Subject/Title: Evaluation of Passive Sub-Slab Depressurization System  
Former TRW Microwave Site, 825 Stewart Drive, Sunnyvale, CA

**Re: Evaluation of Passive Sub-Slab Depressurization System, Former TRW Microwave Site, 825 Stewart Drive, Sunnyvale, California (CERCLIS ID#CAD00915988)**

SUBJECT: Passive Sub Slab Depressurization (SSD) System Operation and Maintenance Plan (Document Control Number [DCN] FY22SEMD\_161) and Evaluation of Passive SSD System, Former TRW Microwave Site, Sunnyvale, California

**Figure 1** shows an aerial view of the three vents on the Main Building Roof and the two vents on the West Building roof and their proposed relocation outside the 25-foot spheres drawn around each intake.

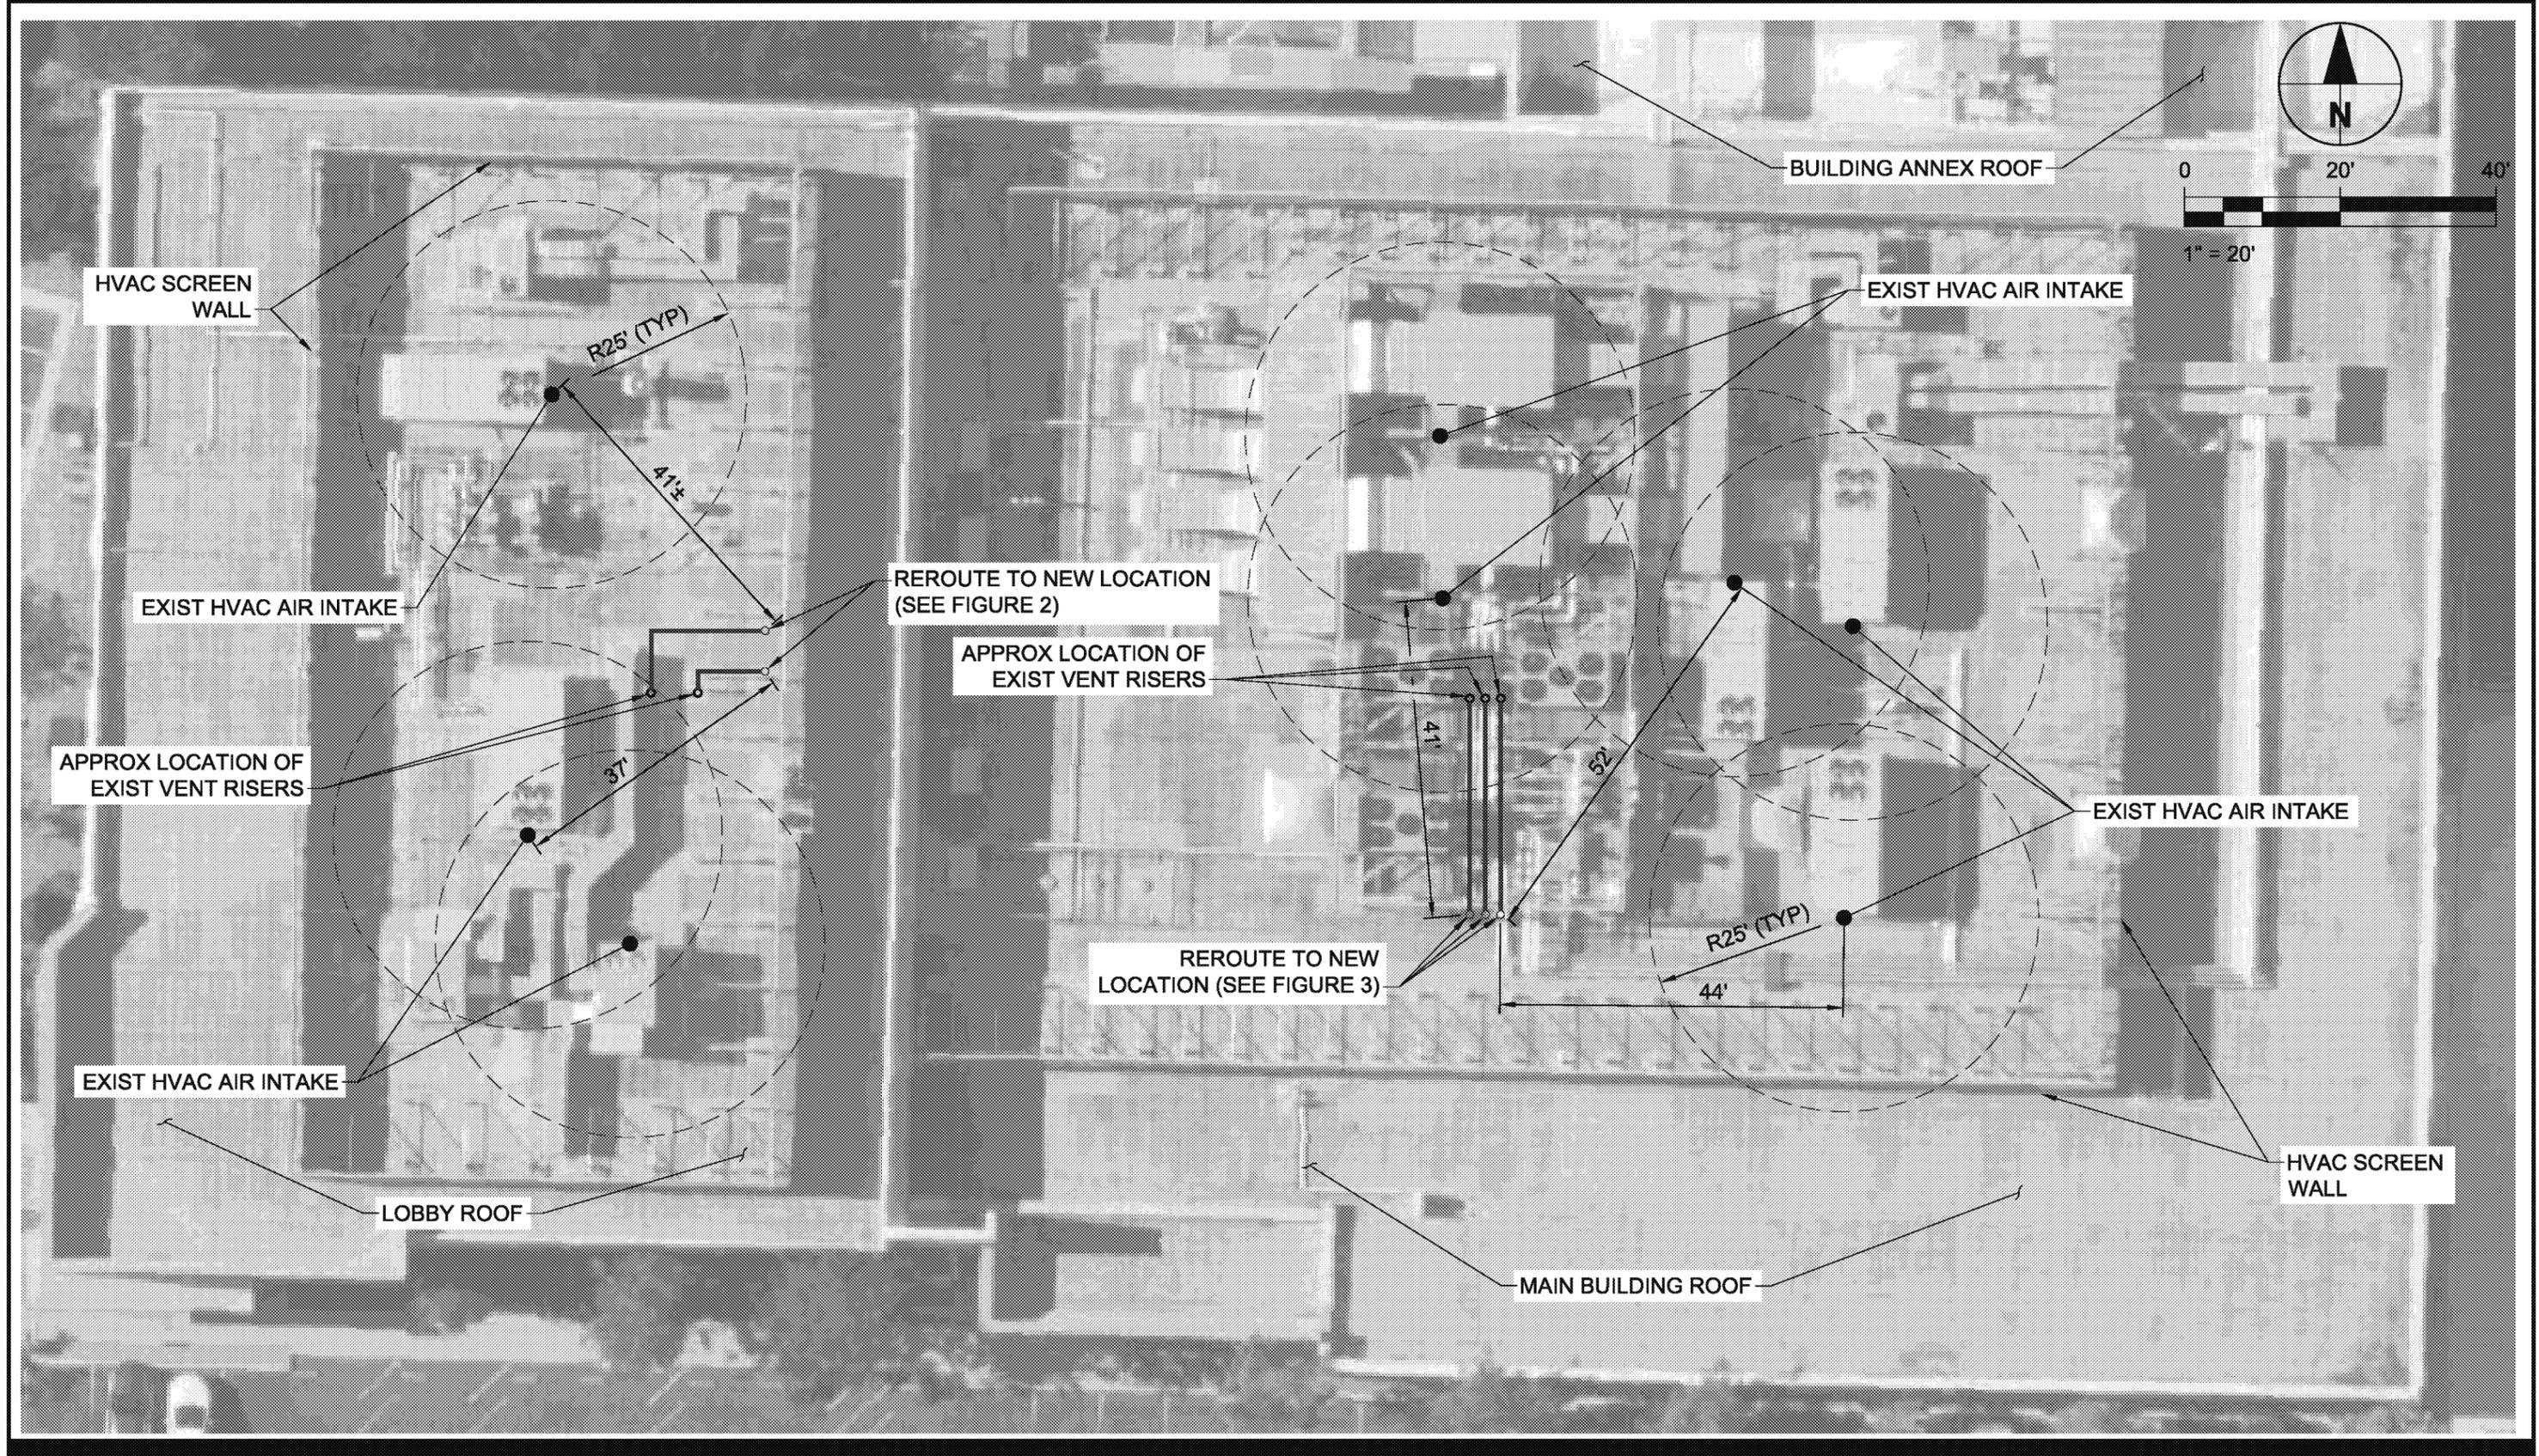
4. [SSD Evaluation; Duct] The design selected introduces long horizontal duct runs and several duct bends on the roof. These features will reduce the effectiveness of the system by causing resistance to air flow.

5. [SSD Evaluation; Vent height] The current height proposed does not appear to be sufficient to clear obstructions. Clearing obstructions is important for dispersion of pollutants and to provide sufficient exposure to wind (which provides part of the driving force for proper passive SSD operation).

6. [SSD Evaluation; Location of HVAC intakes] The HVAC intake location is mislabeled. Please correct this and verify that the other HVAC intakes were properly located.
